MEMORANDUM – S67 FURTHER INFORMATION

Subject: Fast-Track Approvals Act 2024 (**FTAA**) – FTA-2502-1019 Drury Metropolitan Centre – section 67 Matters

Date: 23 June 2025

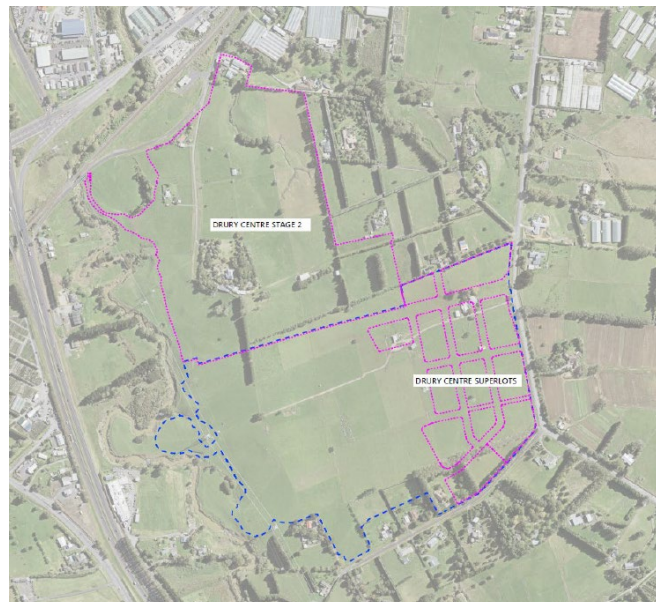
Accordingly, a restricted discretionary activity land-use consent under the NES:CS and a controlled activity contaminant discharge consent are being sought, based on the findings of the DSI, Aurecon, 2021), which confirmed the presence of contamination. Soil testing undertaken across various project stages had identified localised areas of surface soil that exceed the permitted activity soil acceptance criteria under the Chapter E30 of the AUP(OP) and/or human health criteria for commercial and/or residential land use (as shown in figure from the DSI depicted below).

While most of the areas of concern related to the rural residential dwellings and their outbuildings including offal and/or burn pits, and the storage and usage of super-phosphate fertiliser, the DSI confirmed the presence of a landfill at 108 Flanagan Road, which was identified to be more significant than typical farming practices (identified in pink in the figure above).

Although this landfill area has now been excluded from the Stage 2 area (as per Figure 12 in the AEE, and shown below), the extent, depth, and volume of the landfill remains undetermined, with preliminary estimates suggesting it may cover approximately 1 hectare. The DSI had recommended that further investigation be undertaken to assess potential impacts of the landfill on the proposed development.

Given the localised and shallow nature of other identified contamination, this former landfill represents a potential ongoing concern, including to the current proposed earthworks in Stage 2. While this has not addressed in detail in the current application until the landfills characteristics and risks are fully understood, a development buffer zone should be established around the landfill perimeter to ensure safe working conditions and mitigate any risk to future site occupants. Its presence and potential risk in terms of 'HAIL H' under the NES:CS needs to be assessed as part of this current application.

- a) Clarify whether a development buffer zone is proposed around the former landfill area to ensure safe working conditions and mitigate potential risk to site occupants. If so, please provide a plan showing the extent of this buffer and rationale for its size.
- b) Confirm whether the presence of the landfill has been assessed in accordance with the HAIL H classification under the NES:CS, and provide a clear assessment of its implications for the activity status of the proposal and relevant consent requirements.
